DESIGN		<b>DART AEROSPACE LTD</b>	
DRAWN	RF	HAWKESBURY, ONTARIO, CANADA	
CHECKED		DRAWING NO.	REV. F
MFG. APPR.		D407-667-245	SHEET 3 OF 4
APPROVED		TITLE	SCALE
DE APPR.		CROSSTUBE ASS'Y (407 HIGH AFT)	NTS
DATE 08.11.06		COPYRIGHT © 2002 BY DART AEROSPACE LTD	
		THIS DOCUMENT IS PRIVATE AND CONFIDENTIAL AND IS SUPPLIED ON THE EXPRESS CONDITION THAT IT IS NOT TO BE USED FOR ANY PURPOSE OR COPIED OR COMMUNICATED TO ANY OTHER PERSON WITHOUT WRITTEN PERMISSION FROM DART AEROSPACE LTD.

DRAWING NO. D407-667-245	TITLE CROSSTUBE ASSY (407 HIGH AFT)	REV. F	DART AEROSPACE LTD ENGINEERING ORDER		D.E.O. NO. D407-667-245-F-1	SHEET NO. SHEET 1 OF 2	SCALE NTS
DRAWN <i>[Signature]</i>	CHECKED <i>[Signature]</i>	MFG. APPR. <i>[Signature]</i>	APPROVED <i>[Signature]</i>		DE APPR. <i>[Signature]</i>		
DATE 11.04.08	DATE 11.04.12	DATE 11.04.12	DATE 11.04.12		DATE 11.04.12

REMOVED ABRASION STRIP IN FAVOR OF A THIN LAYER OF PROSEAL 890.

REPLACE MAGNOBOND WITH 3M DP460 SCOTCH-WELD EPOXY ADHESIVE

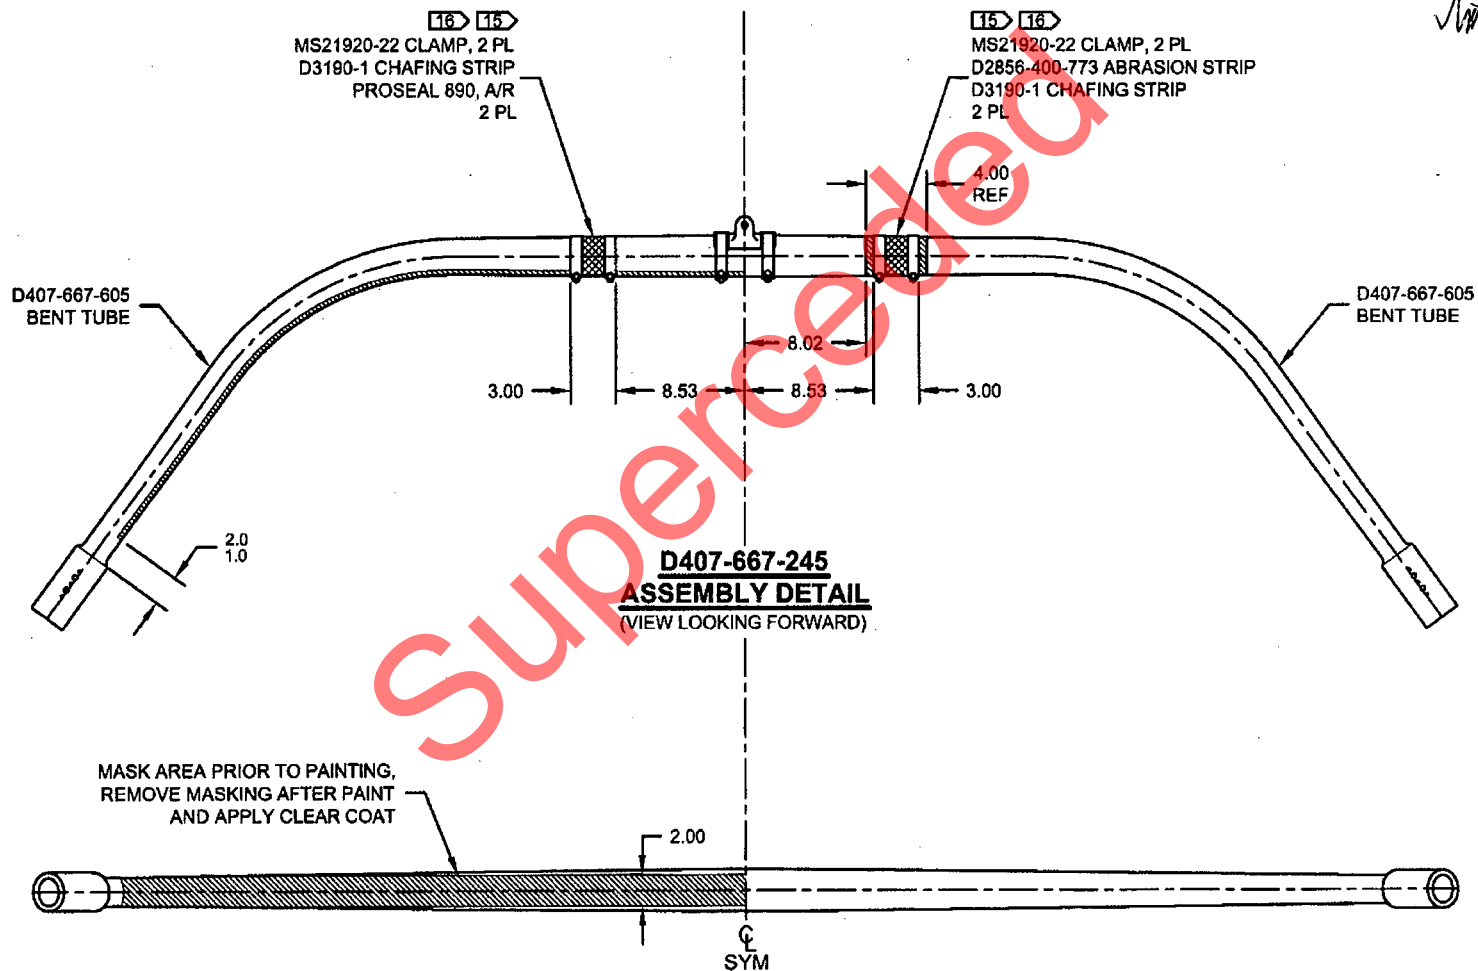
NOTES 2 AND 15, SHEET 1 ARE AMENDED AS FOLLOWS:

- 2) FINISH: CHEMICAL CONVERSION COAT PER DART QSI 005 4.1  
PRIME INSIDE AND OUTSIDE PER DART QSI 005 4.2  
MASK UNDERSIDE OF CROSSTUBE AS SHOWN (HATCHED AREA) AND  
PAINT OUTSIDE PER DART QSI 005 4.2  
REMOVE MASKING AND APPLY CLEAR COAT
- 15) APPLY A THIN COAT OF PROSEAL 890 ON INSIDE CONCAVE SURFACE OF D3190-1  
CHAFING SHIELDS AND LET CURE PER MANUFACTURER'S INSTRUCTIONS. INSTALL  
PROSEAL D3190-1 CHAFING SHIELDS ONTO CROSSTUBE BY APPLYING A THIN COAT  
OF PROSEAL 890 ONTO CROSSTUBE. BE SURE TO ELIMINATE ANY AIR GAPS.

IS:

WAS:
